Log R40 DOT 973C Rec R-73-13 and 14
UNITED STATES OF AMERICA
NATIONAL TRANSPORTATION SAFETY BOARD
WASHINGTON, D.C.

ISSUED: April 25, 1973

SAFETY RECOMMENDATION R-73-13 & 14

Figure 2

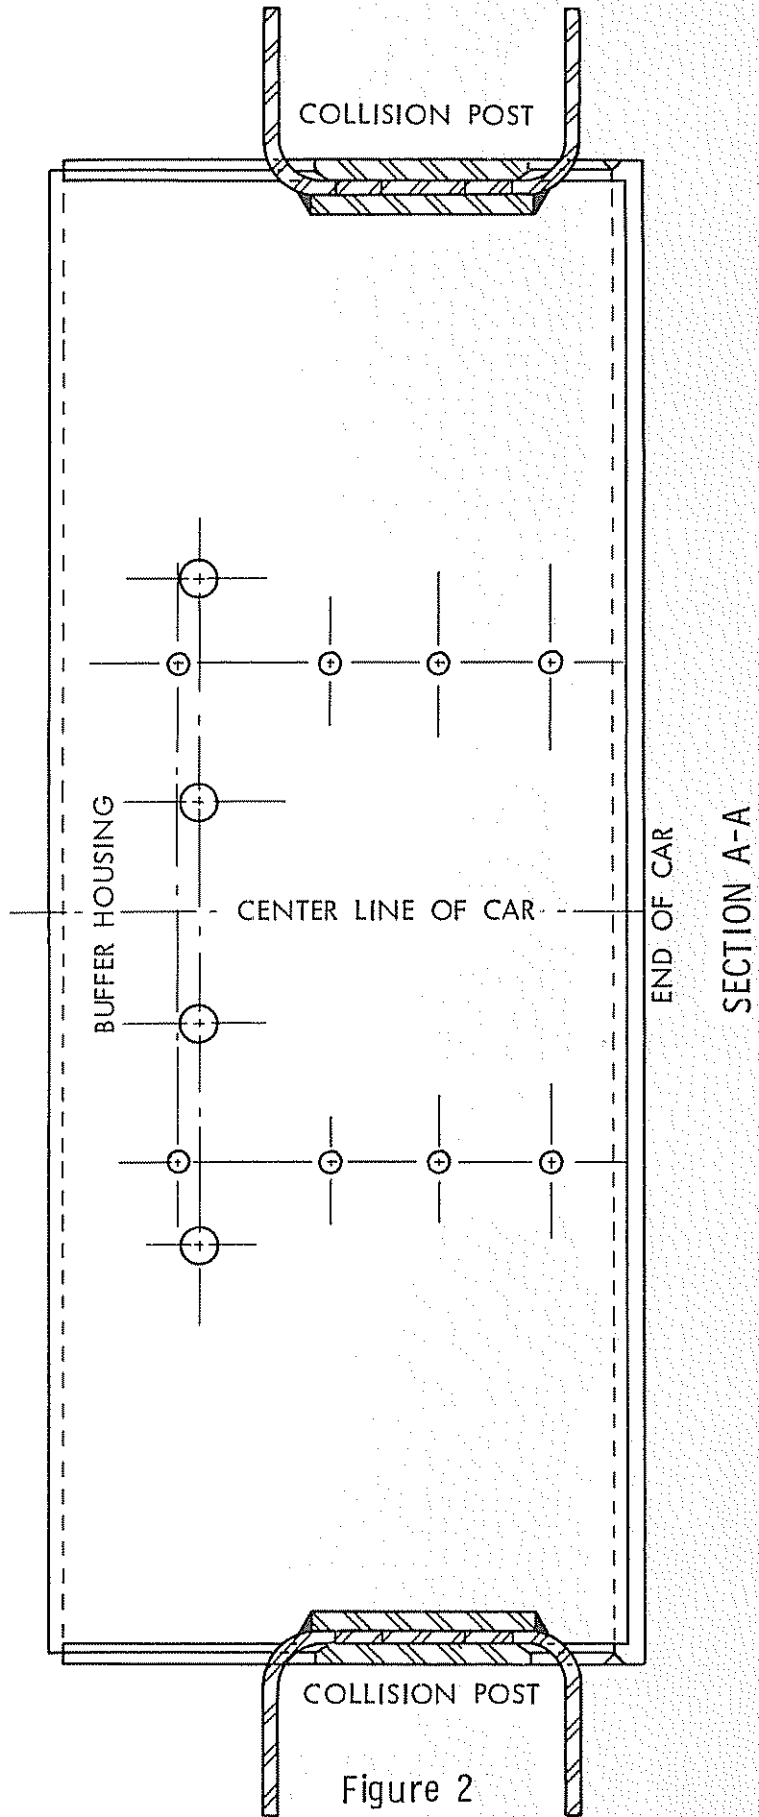
It was disclosed at the hearing that there was incomplete fusion in about 75 percent of the weld attaching one collision post to the underframe. The collision post was secured to the underframe by a 1/2-inch-thick attachment plate, the bottom edge of which was beveled at a 45° angle for welding purposes. The depth of the bevel was only 5/16th of an inch instead of the full 1/2-inch thickness of the plate as originally designed and shown on the drawing. The

depth of the bevel did not provide access to permit welding over the full ½-inch thickness. In addition, only 25-percent fusion was achieved in the accessible area.

The possibility of not achieving a good weld with full penetration was quickly determined during the construction of the cars by the production department of St. Louis Car Division. The bevel was reduced in depth and an additional weld adjacent to the weld in the beveled area was added in an effort to compensate for any deficiencies of penetration. This effective design change was not, however, changed on the drawing. These factors are illustrated by the attached sketches based upon exhibits in evidence. The added weld is visible in this exhibit.

The added weld did not solve the problem. First, as can be seen in the sketch, the added weld material was distant from the location at which it could add to the strength of the weakest section. This section was limited by the 5/16-inch bevel. Second, the poor fusion at the weakest section could not be corrected by metal added to the outside of the plate.

Fusion to the full depth of the plate was assumed in the calculations for the collision posts based on the original drawing. Any reduction of cross section, such as that produced by the smaller bevel or poor fusion, would reduce the shear strength of the collision post to below the required 300,000 pounds.

1. Review the current design of collision posts used on highliner cars and determine whether the attachments comply with the requirements of 49 CFR 230.457.
2. Take the necessary enforcement action to assure that highliner cars meet the requirements of 49 CFR 230.457.

SECTION B-B
Figure 3

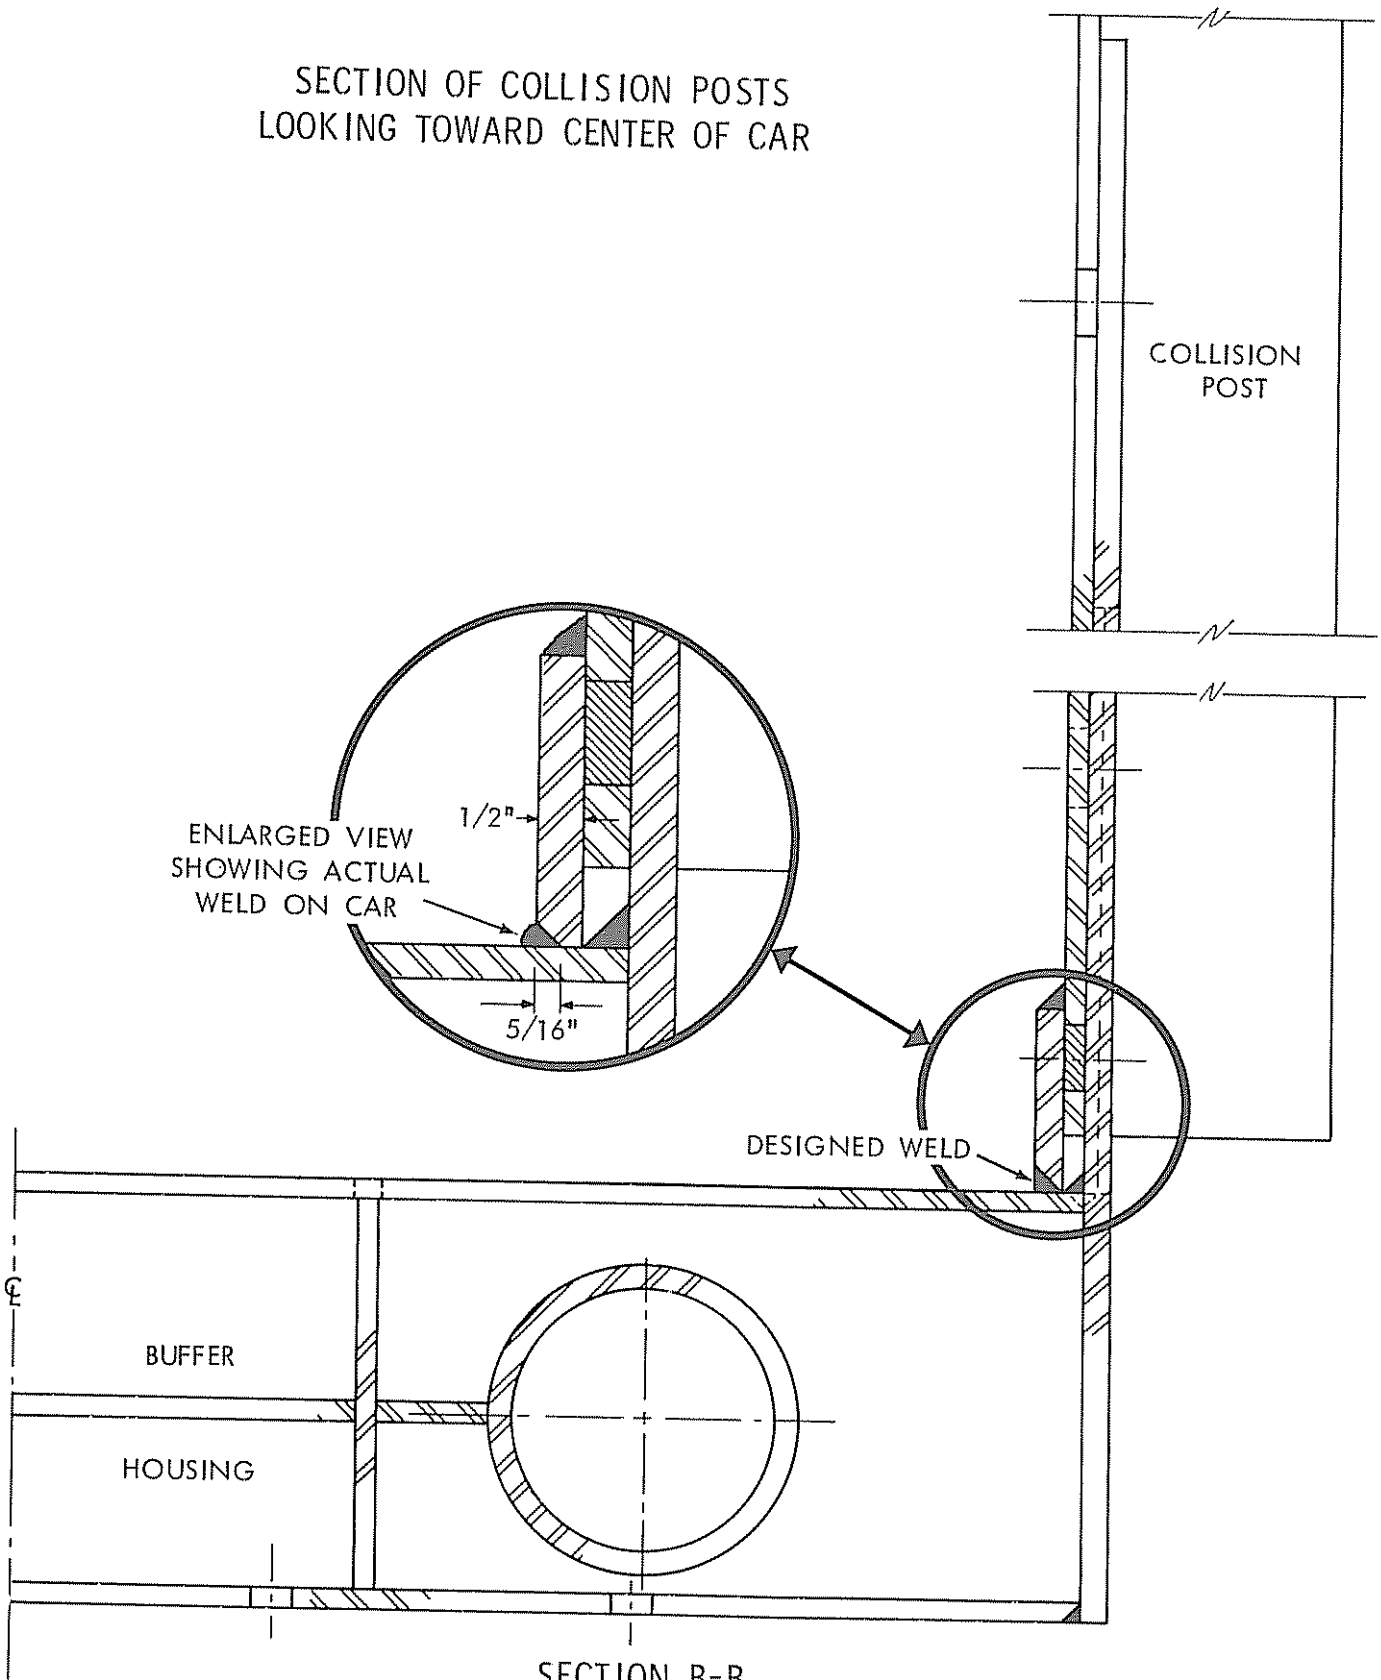
The reinforcing plate of the collision posts is attached to the underframe by welds of the type cited in the American Welding Society Handbook. A sound weld was not obtained in this case. The impact of a collision can subject these welds to severe bending stresses, as well as impact loading, both of which are warned against. The calculations assumed joint penetration to the full $\frac{1}{2}$ inch depth of chamfering, although this is not supported by the handbook.
